WBC Highway Comments

MEMORANDUM

From:	Gordon Adam Development Control		
Service	SDL Highways	App No:	242279
Address:	Land west of Old Wokingham Road and North and South of, Easthampstead Road, Wokingham, (Proposed SDL Extension).		
Proposal:	Outline application with all matters reserved except means of access for up to 180 dwellings and associated infrastructure including open space, play space, landscaping, SuDs and green infrastructure. Please note: The application has been submitted in relation to the area proposed as an extension to the South Wokingham SDL in the Local Plan Update(LPU).		
Type of Development:	Major Dwellings (10+)		
Site Visit Made:	Yes/No

DESIGNERS RESPONSE

Scale 1:500 @ A2	Date FEB 2023	Drawn TDM	Checked NB
Drawing No A218-014			Revision P5

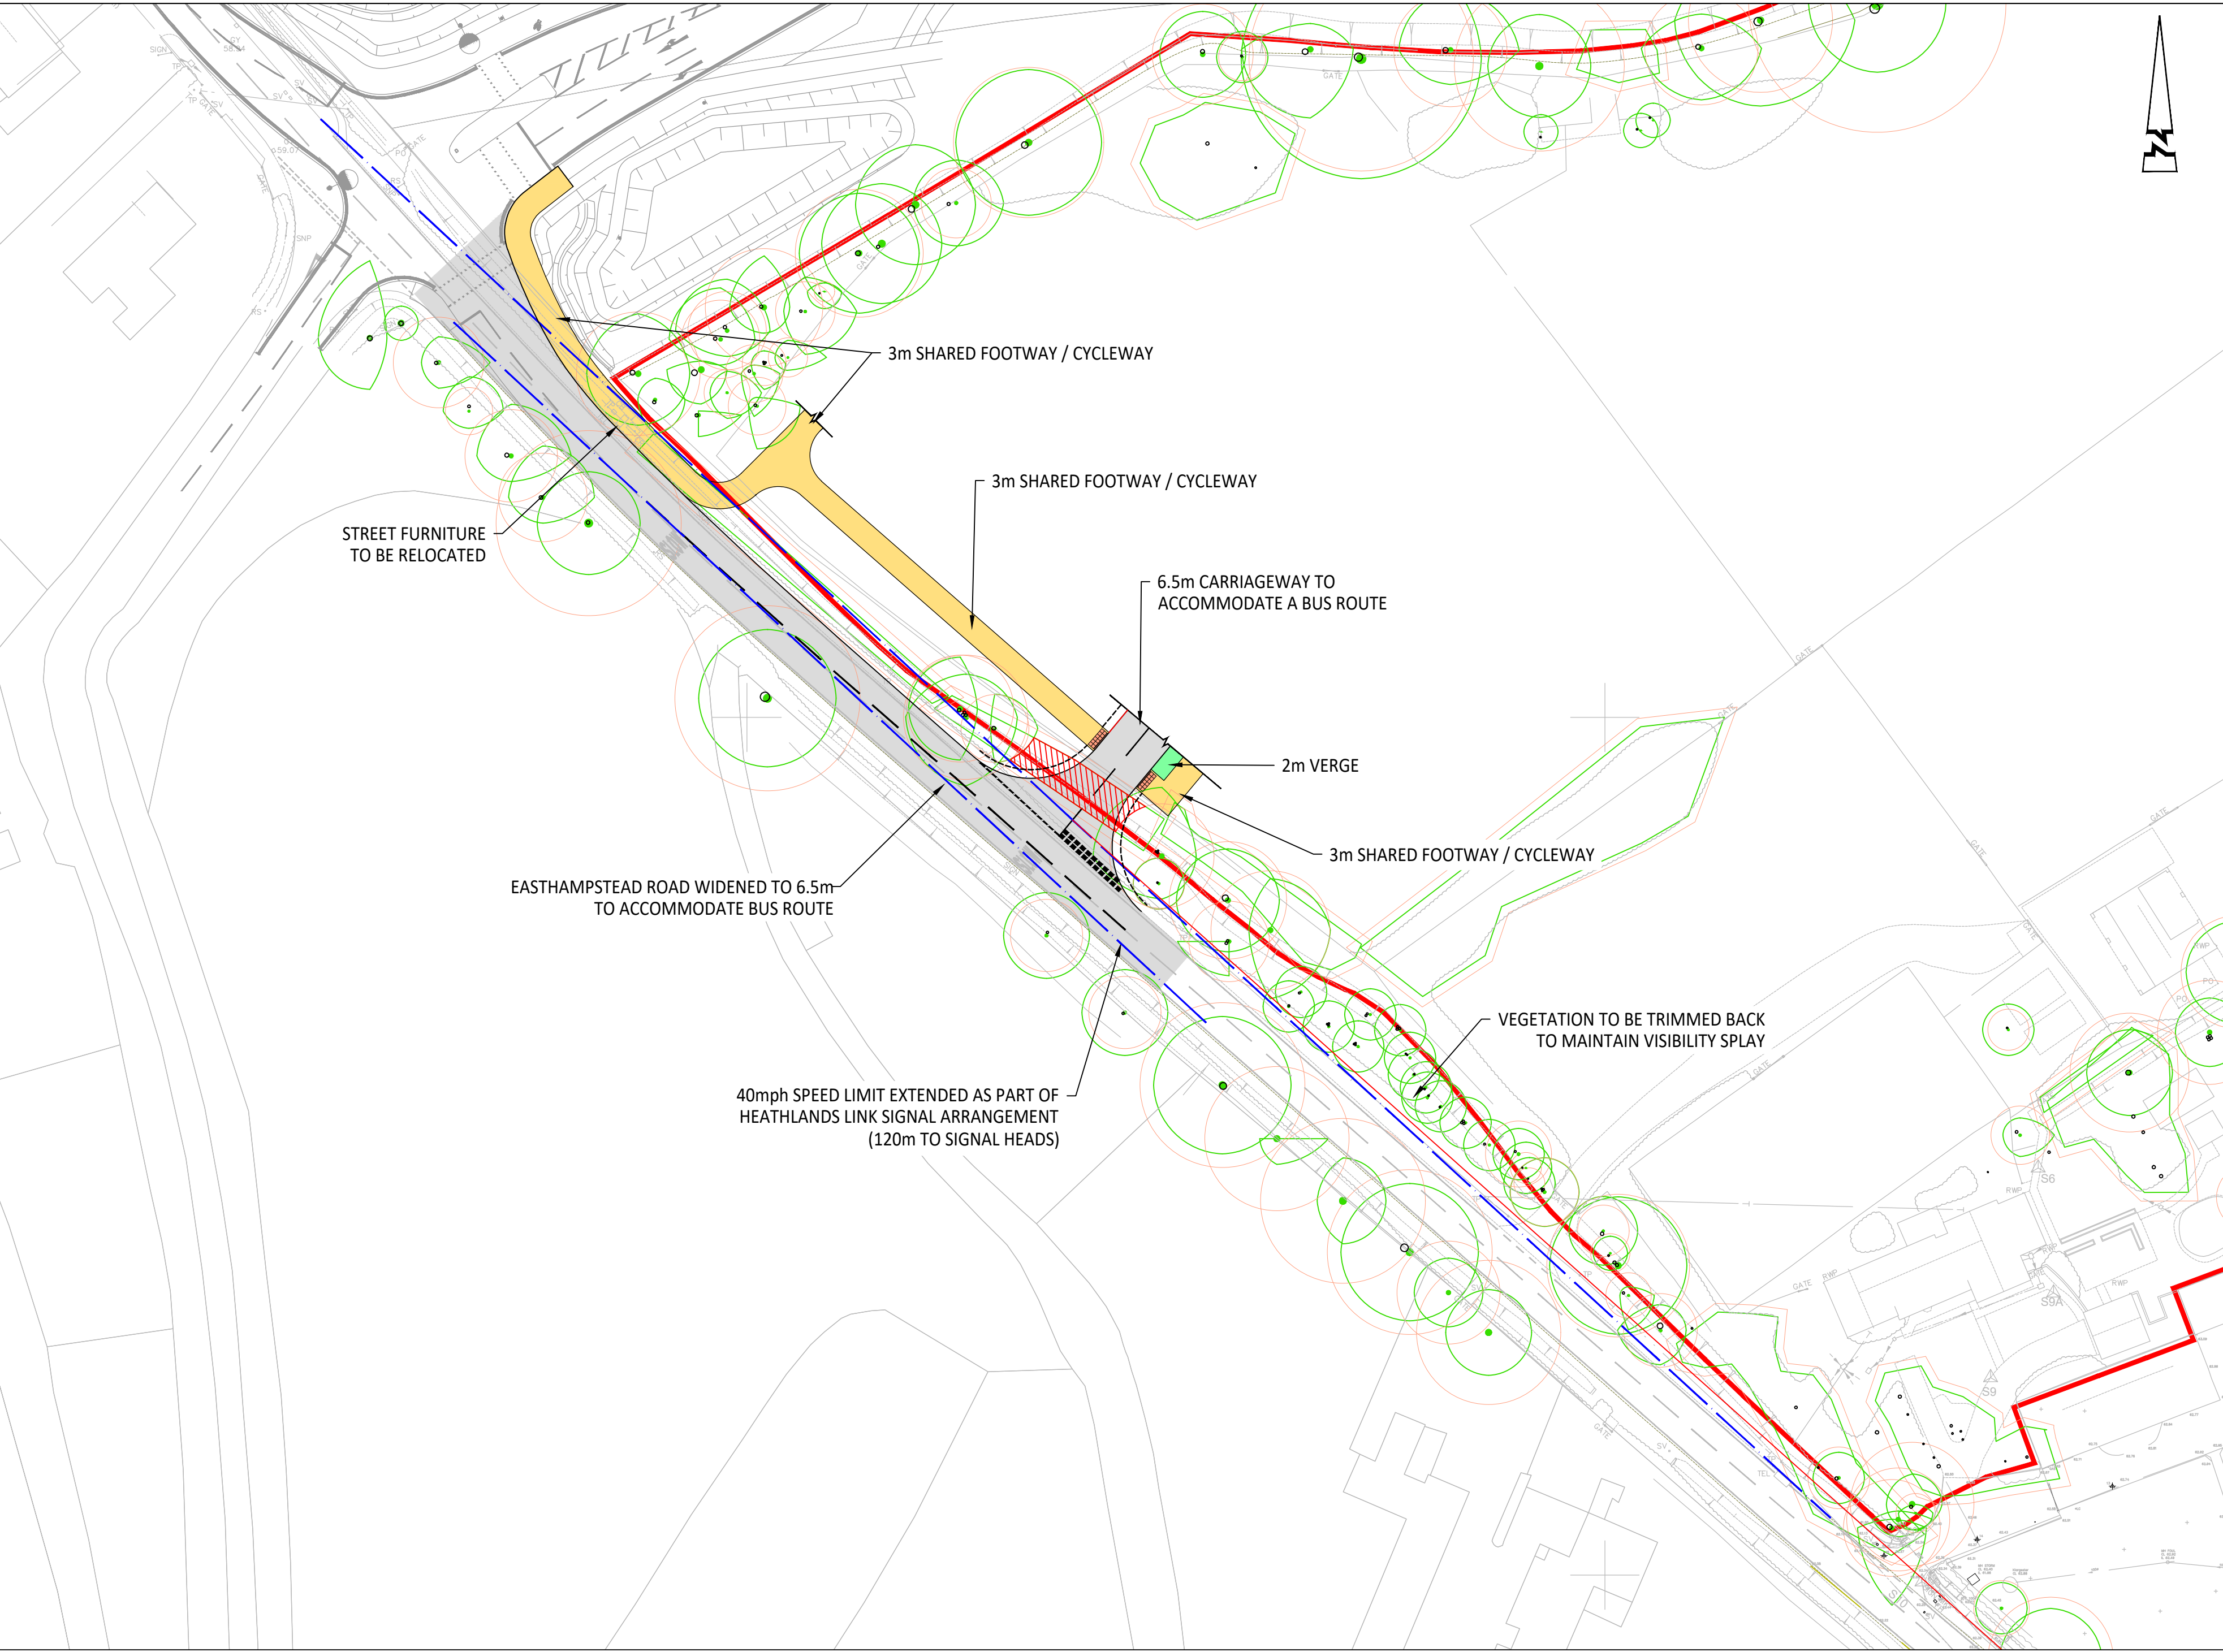
Visibility from the access is restricted by vegetation (see photos above), which will increase the risk of an emerging vehicle being struck by a passing vehicle

2.1.3 Cut back and maintain vegetation to achieve the required visibility

The visibility in this direction has been given as 120 metres, which is appropriate for speeds up to 70 kph. However, the road in this direction is subject to a National Speed Limit, so vehicle speeds are likely to be significantly higher, meaning a longer visibility distance may be appropriate

2.2.4 Carry out speed measurements on this length of road and establish the correct visibility distance. Alternatively, arrange for the existing 40 mph speed limit to be extended further to the southeast to reduce vehicle speeds on the approach to the access.

No footway is indicated on the northwest side of the new access road. The auditors were unsure of the context of the development to the north of Easthampton Road, however, if there is a desire for pedestrians to walk on this side of the access road, they may choose to walk in the carriageway, where they will be at risk of being struck by vehicles

- 2.3.3 Provide a footway to the north-west side of the access road if considered appropriate

- 2.4.2 Risk of cycles colliding with street furniture
- 2.4.3 An existing power pole and two utility cabinets will obstruct the proposed shared use path if left in place

- 2.4.4 Relocate Street furniture out of the path.

2.1.4 *Vegetation will be cut back as appropriate and maintained to ensure visibility is achievable.*

2.2.5 *While there is scope for the provision of a 2.4m x 215m visibility splay (60mph) to the east at the proposed junction, it should be noted that as part of the SDL wider works, a new 4-arm signalised junction is proposed at the Easthampstead Road / Heathlands Road junction.*

2.2.6 *As part of this, forward visibility to the proposed signal heads is to be provided commensurate with a 40mph design speed, which extends past the location of the proposed site access.*

2.2.7 *As such, access would be located within a 40mph zone, to which the proposed 120m visibility has been designed.*

- 2.3.4 *The proposed development layout is currently under review and has yet to be finalised in detail. However, at this outline stage, the land on the northern edge of the access road is to be used as a balancing pond.*
- 2.3.5 *As part of the pedestrian and cycle access strategy, a 3m shared route is provided at the northern corner of the site, as well as a crossing point over the access road and continuation along its southern edge.*
- 2.3.6 *As such, it is considered that the provision of a footway on the northwest site of the access road is not required.*

- 2.4.5 The relocation of existing street furniture will be taken into consideration as part of the access works.

Drawing No	Revision
A218-029	P3

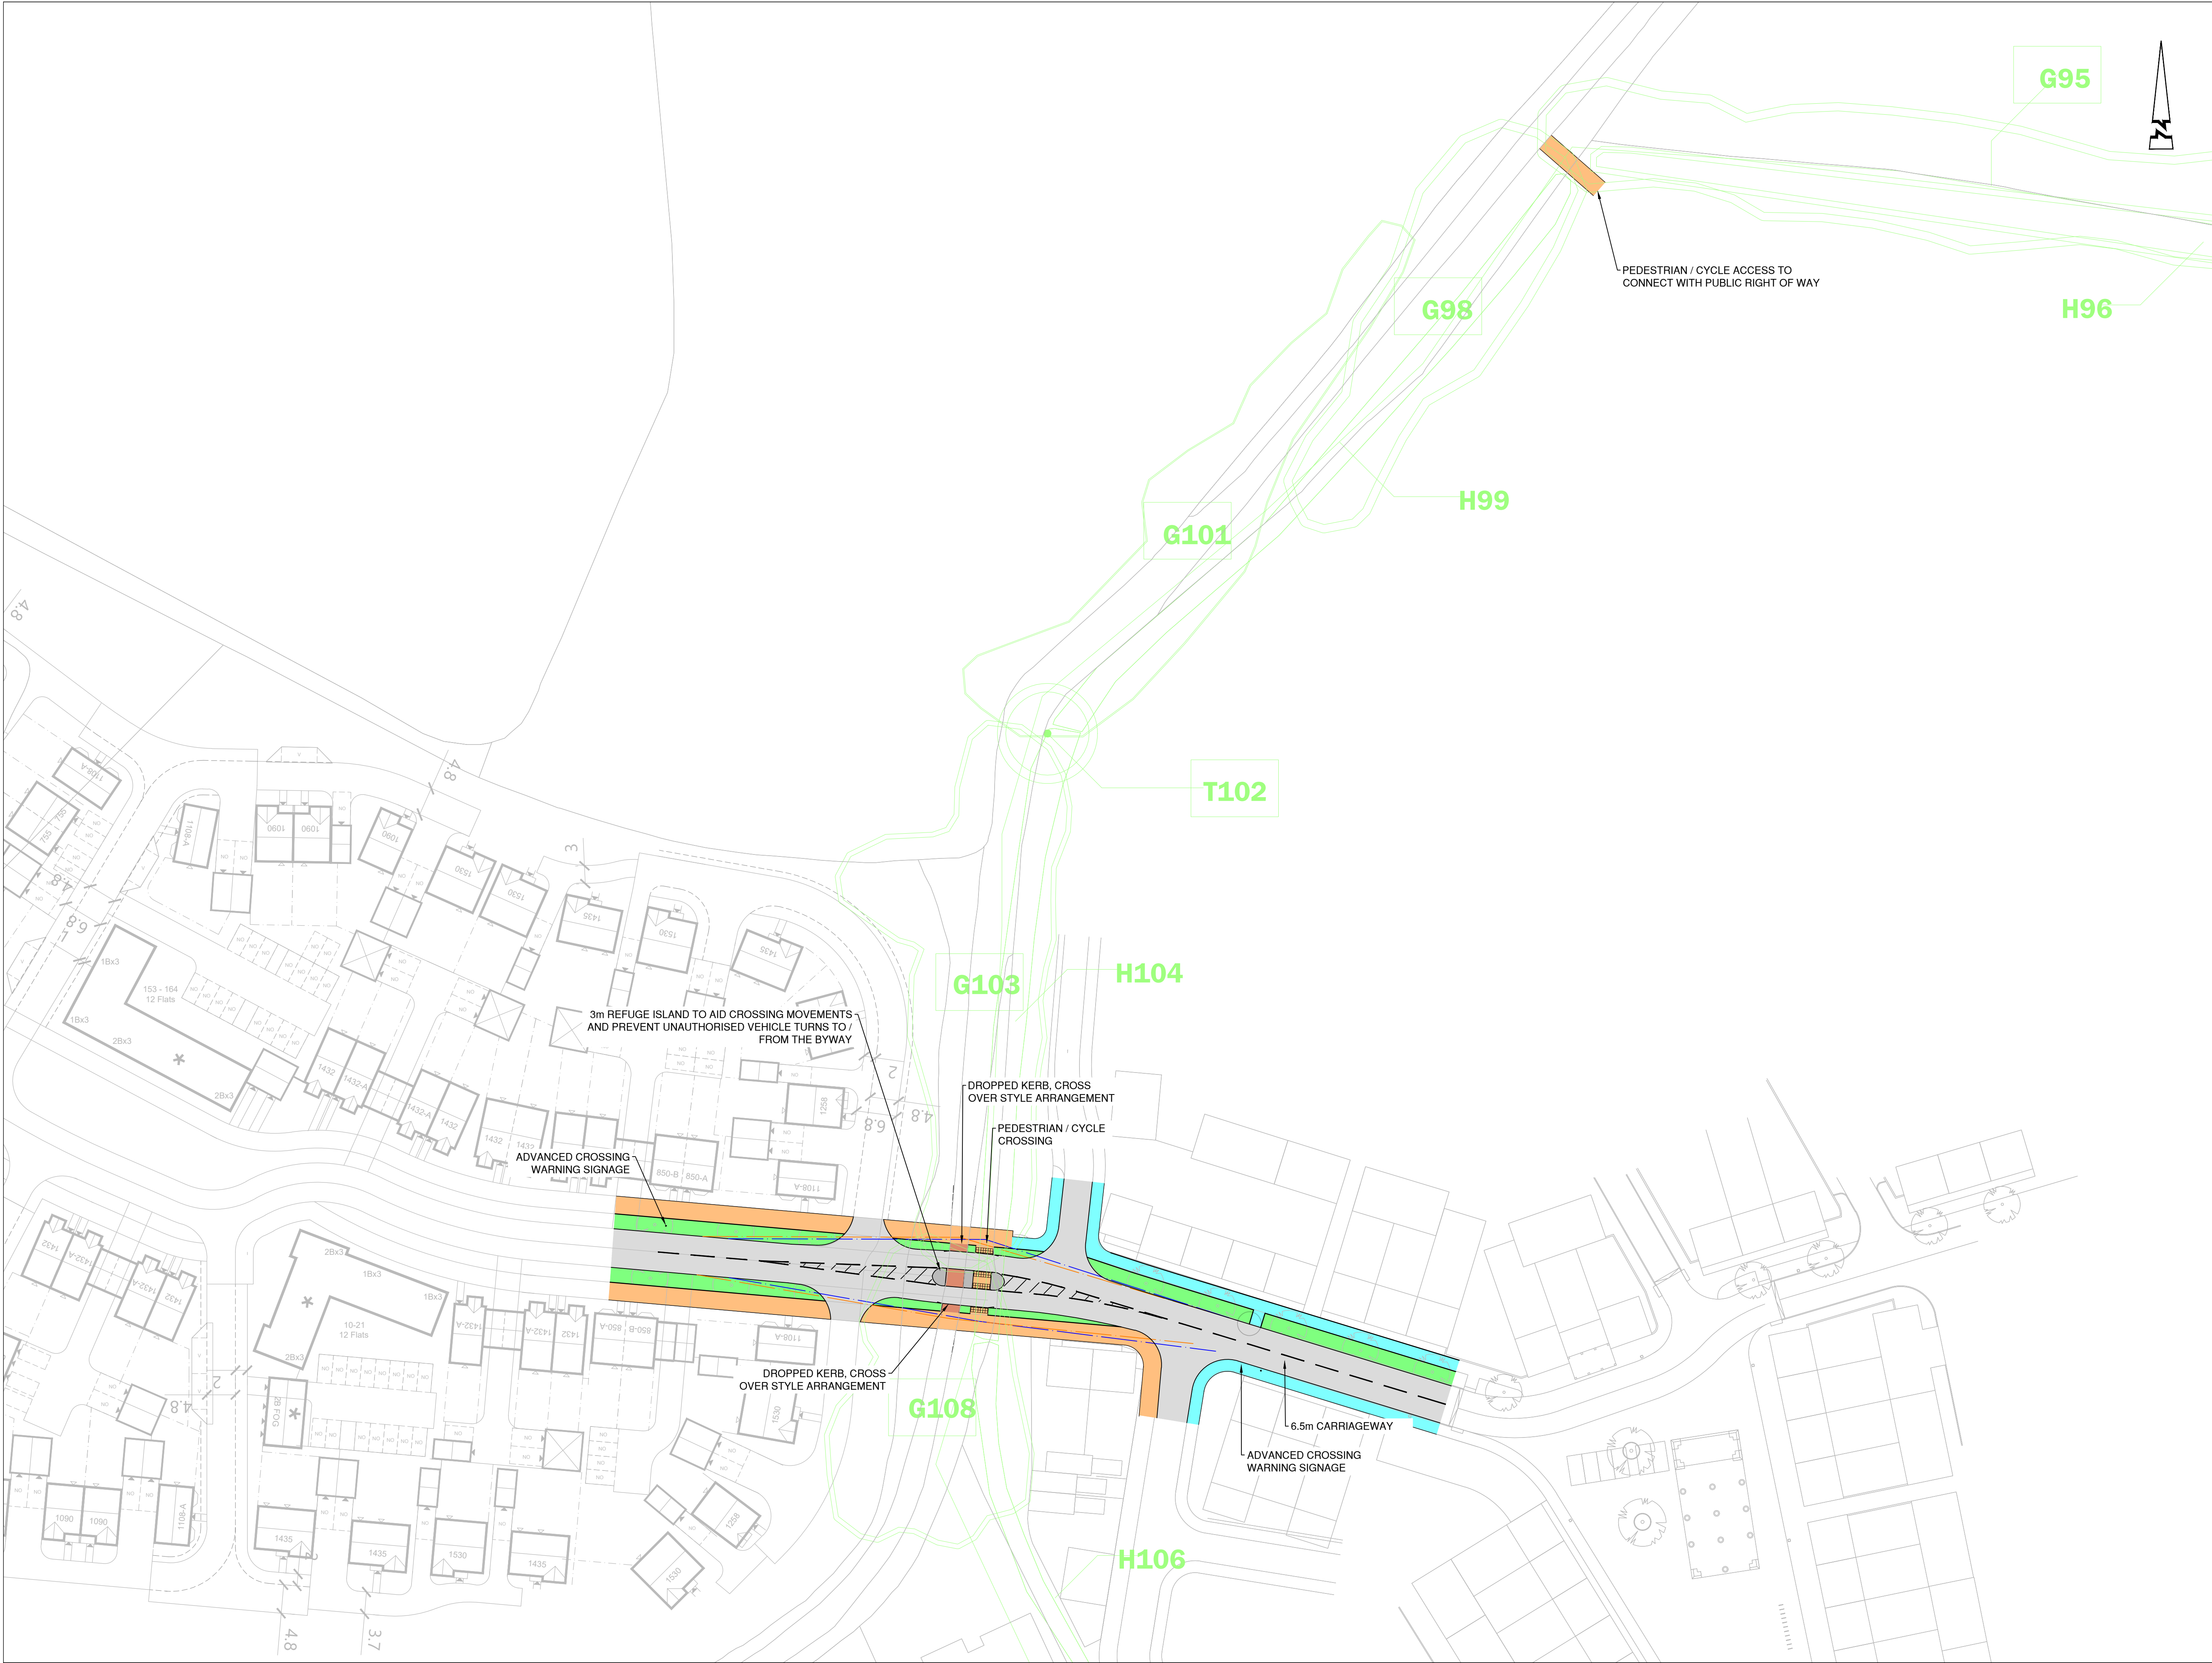
Recommendation – Provide illuminated or reflective bollards at either end of the island

Recommendation – Provide corduroy tactile paving and appropriate path signage at this point

Recommendation – Provide appropriate tactile paving, and ensure the sign post does not conflict with or obstruct the crossing

Recommendation – Provide swept path drawings to show that large vehicles can turn out of the side roads and negotiate the island safely
